MARINER OUTBOARDS

service bulletin

No. 92-9

Required Fuel Filter Replacement 40 thru 275

Figure 1.

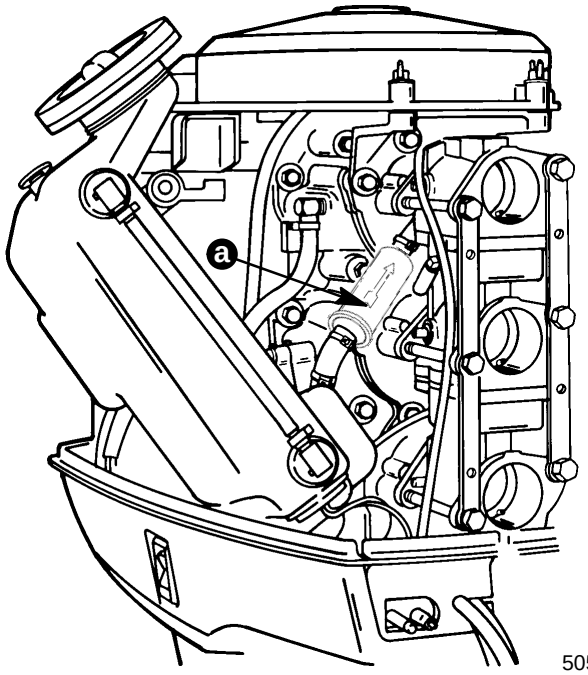
Outboards listed, require the replacement of the in-line fuel filter (Figure 1) to prevent the possibility of fuel leakage. Affected in-line fuel filters may develop a leak at the sonic weld area. (Figure 2)

a - Fuel Filter Location (50/60 Model)

Figure 2.

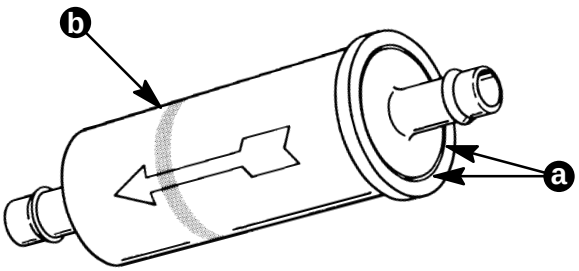
A blue or black marker ring around the fuel filter body (Figure 2) indicates filters that DO NOT have to be replaced.

a - Sonic Weld Area
b - Blue or Black Marker Ring
